**Draft Final Decision Document
for the Basin A Neck Groundwater Intercept
and Treatment System Interim Response Action
at the Rocky Mountain Arsenal**

COMMENTS ON THE PROPOSED DECISION DOCUMENT
FOR THE INTERIM RESPONSE ACTION FOR
BASIN A NECK GROUNDWATER INTERCEPT AND TREATMENT SYSTEM
SEPTEMBER, 1988

STATE COMMENTS ON PROPOSED DECISION DOCUMENT
FOR THE BASIN A NECK GROUNDWATER INTERCEPT AND
TREATMENT SYSTEM INTERIM RESPONSE ACTION AT THE
ROCKY MOUNTAIN ARSENAL, SEPTEMBER 1988

Figure 5.
Saturated Alluvial Thickness
in the
Basin A Neck Area

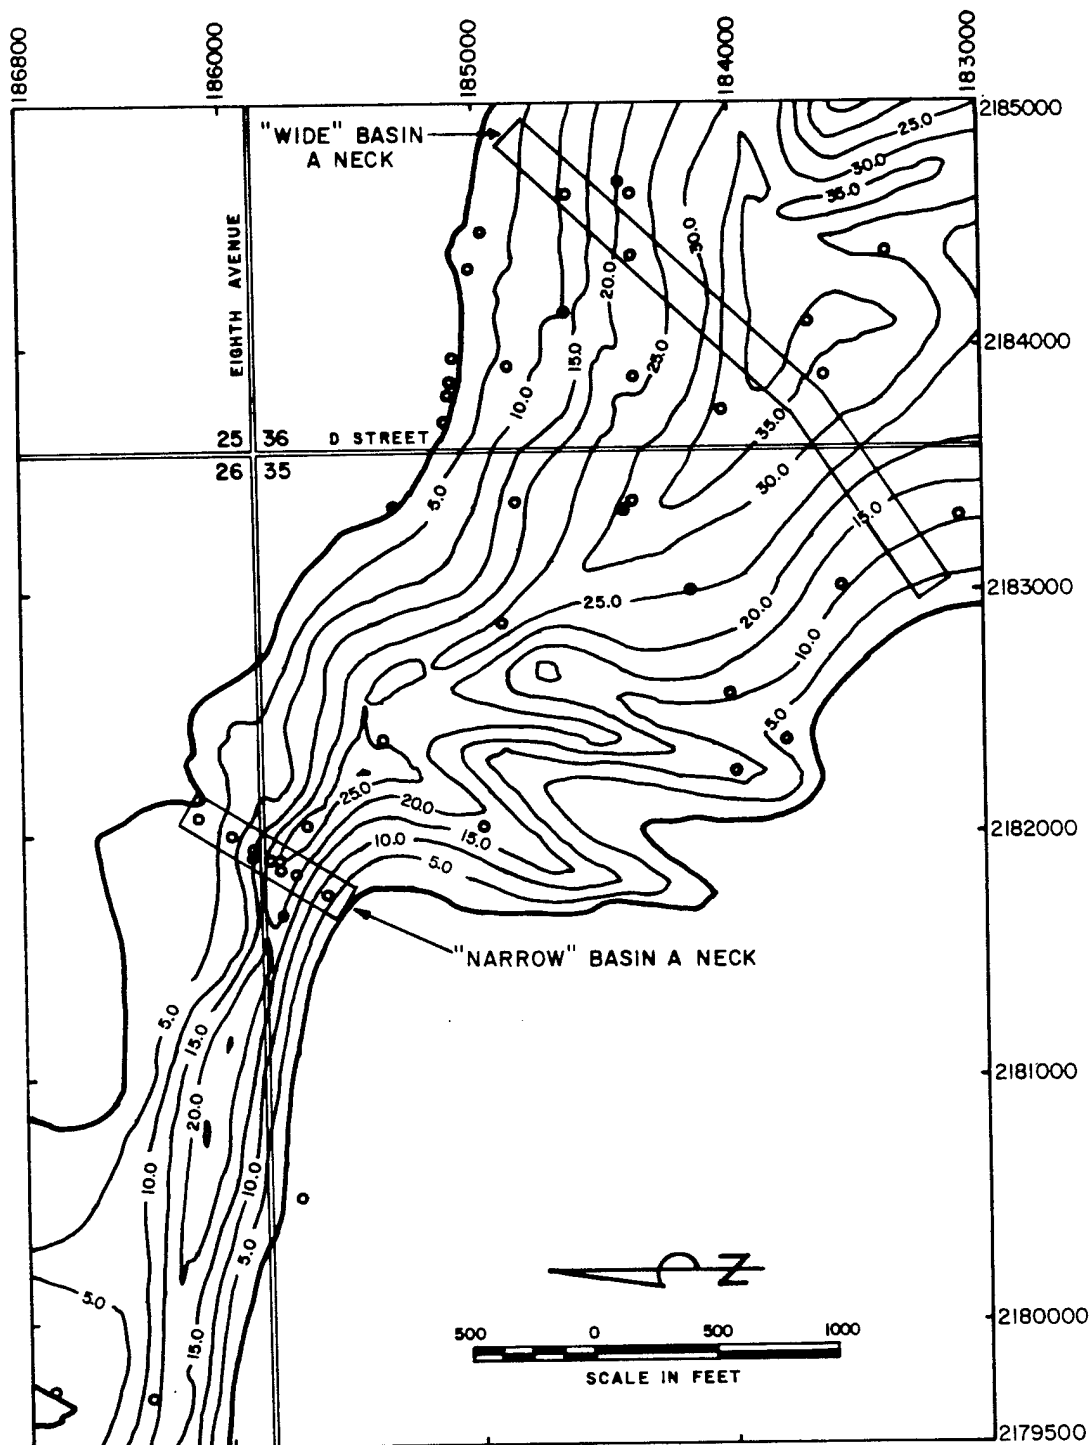
3. Further characterization of the Basin A neck hydrology and contaminant distribution is needed prior to the selection of the exact location for the system. Four important aspects of a more detailed siting study need to be considered and addressed in the Decision Document. First, the location of the intercept system downgradient of subcropping Denver sand units may result in increased capture of flux being discharged from the Denver units. Second, locating the system closer to the sources (i.e. South Plants area) could result in capturing more contaminants before they migrate into the underlying Denver formation. However, by locating the intercept system upgradient of the "neck" (toward Section 1), the desirable constriction occurring at the "neck" would be lost. Third, the faults and/or fault zones appear to affect the shallow aquifer flow and may affect the operation of the extraction and/or injection systems. Fourth, the northeast Denver sand conduit may have a significant affect on the flow and contaminant movement in the shallow aquifer. These aspects should be investigated and addressed in the Decision Document to assure the optimal site for the system.

Response: As shown on Figure 5, the width of the saturated alluvium in the area of the "wide" Basin A Neck is approximately 2800 feet. Such a statement has been incorporated in the text.
